Sumter City-County Planning Commission

March 28, 2012

MSP-11-51/HCPD-11-58, 650 Jefferson Rd. Caterpillar Plant Expansion (County)

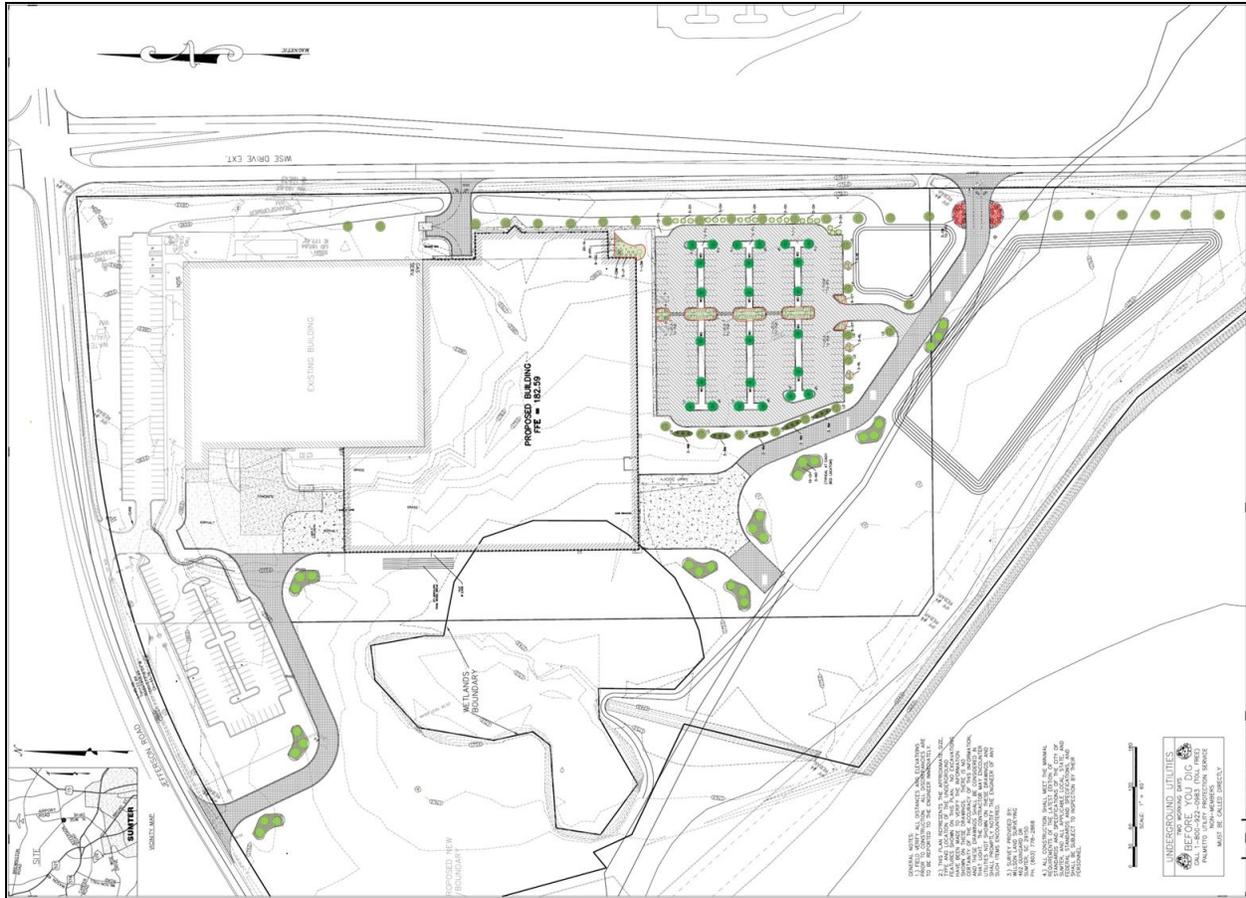
There are established trees and existing landscaping currently on site for the existing building and parking lots. The applicant has submitted a landscape plan that addresses landscaping for the new addition and parking area as well as street front buffering.

In addition to the established plantings, the overall plan calls for the following:

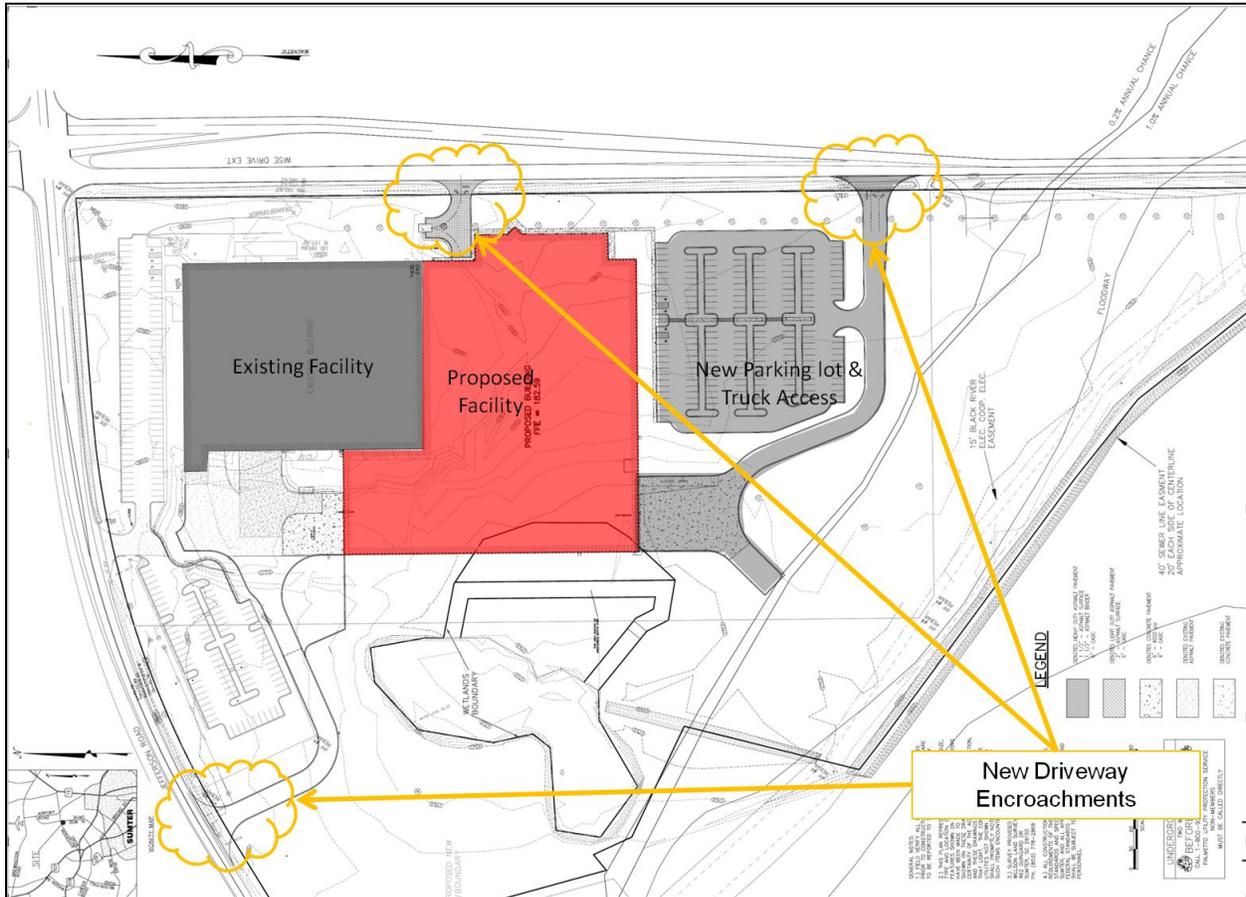
Based on the combined numbers required above, the development would be required to have 111 parking spaces. The submitted plans make accommodation for 188 more parking spaces, as shown on the following page. This meets the Zoning Ordinance requirement for the proposed addition.

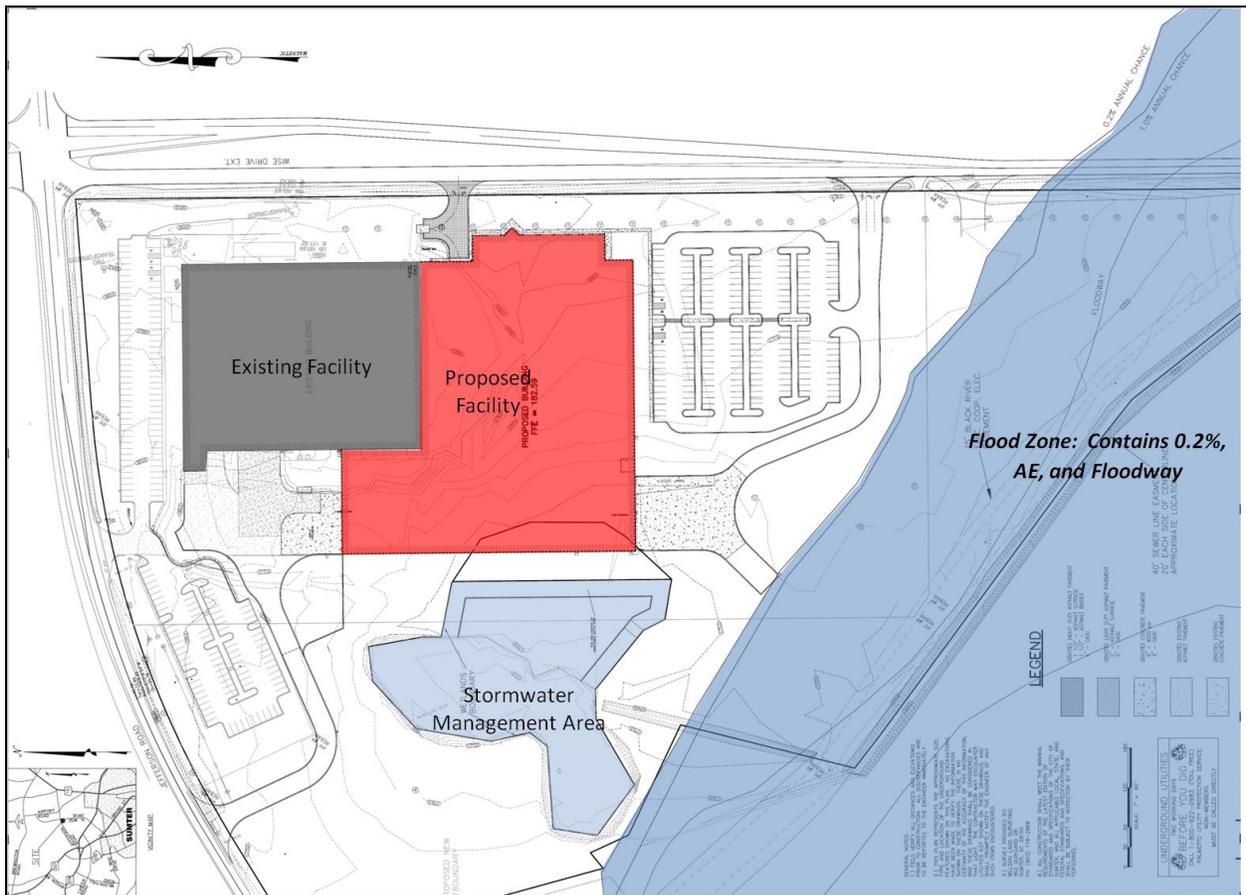
As shown in the graphic on the following page, a parking lot with 188 parking spaces will be constructed next to the facility expansion. An approximate 70' wide drive way gives access to

the 188 space employee parking lot—this parking lot includes four handicapped parking spaces and truck access to the receiving bay on the south side of the facility expansion from Wise Drive. Another drive way approximately 60’ wide provides access to mail trucks or ambulance services on the facility expansion. This access allows only right in and right out movements on Wise Drive. Both proposed driveways will be about 1,500’ apart as shown in the graphic below.

A new driveway, 60’ wide, will be constructed on Jefferson Road for truck access into the proposed facility for shipment of manufactured goods. This proposed driveway will be about 90’ from the existing access point for the employee parking lot on Jefferson Road.

- The proposed driveways on Wise Drive meet the minimum spacing requirements of 325’ of SCDOT ARMS Figure 3-7 standard.
- The proposed “shipment” driveway and the existing employee parking lot driveway on Jefferson Road meet the minimum of 325’ spacing requirement of SCDOT ARMS Figure 3-7 standard.
- The site plan appears to have enough space for truck maneuvering for turning at the shipment and receiving bay areas.

- The access points on Wise Drive and Jefferson Road must be constructed in accordance with the SCDOT standard to accommodate safe ingress and egress for vehicles and trucks.
- Median modification and separate left turn lane from northbound N. Wise Drive.

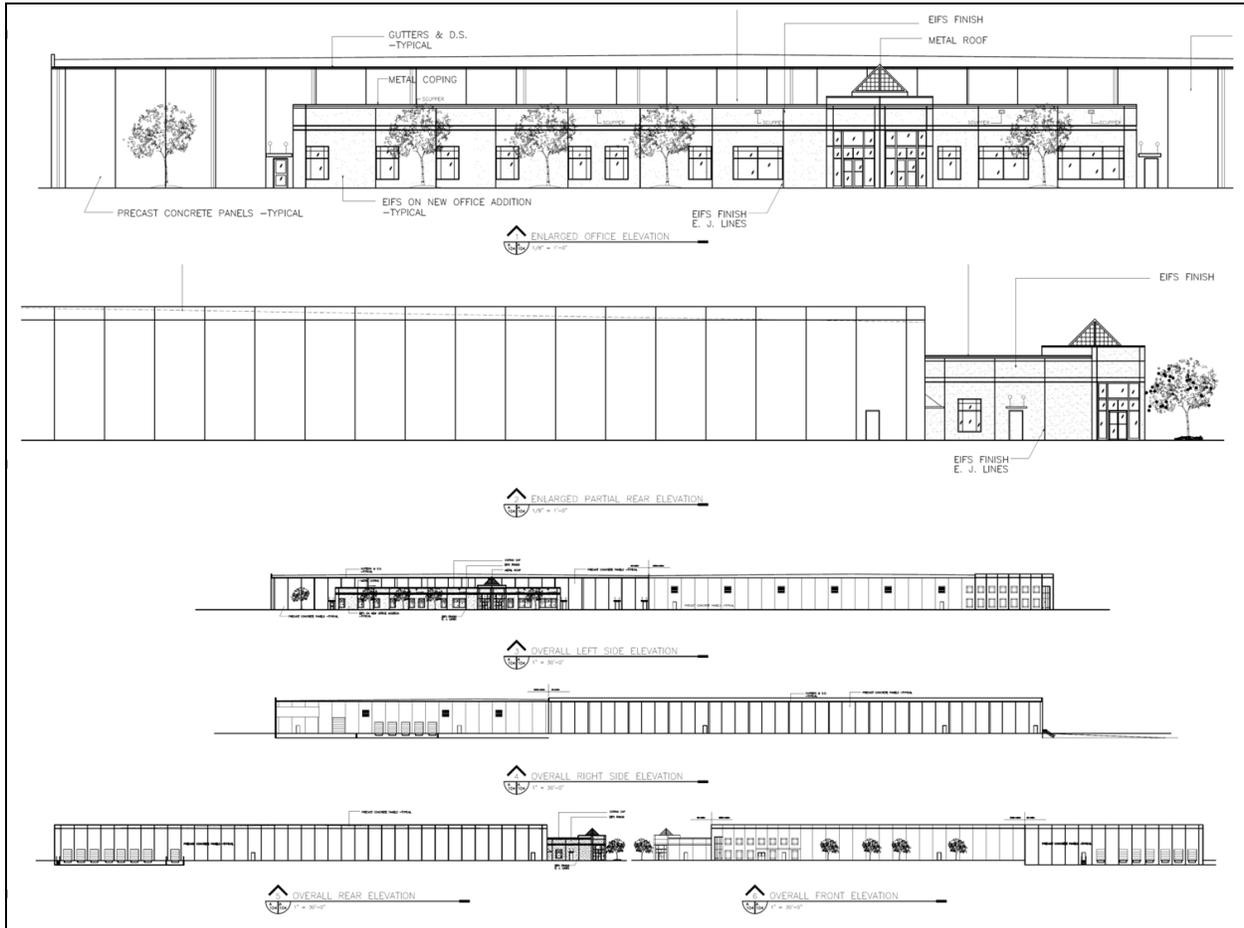
This is a proposed addition to an existing structure that will utilize the same type materials as on the original structure as well as roof pitch and roofing materials.

Proposed exterior materials consists of the following:

- Precast concrete panels with Coping Caps
- EIFS Finish on new Office addition sections
- Aluminum Storefront Doors
- Flush doors with tinted exterior glass
- Aluminum Skylight Pyramid Shape
- Typical gutters

These materials meet Ordinance requirements.
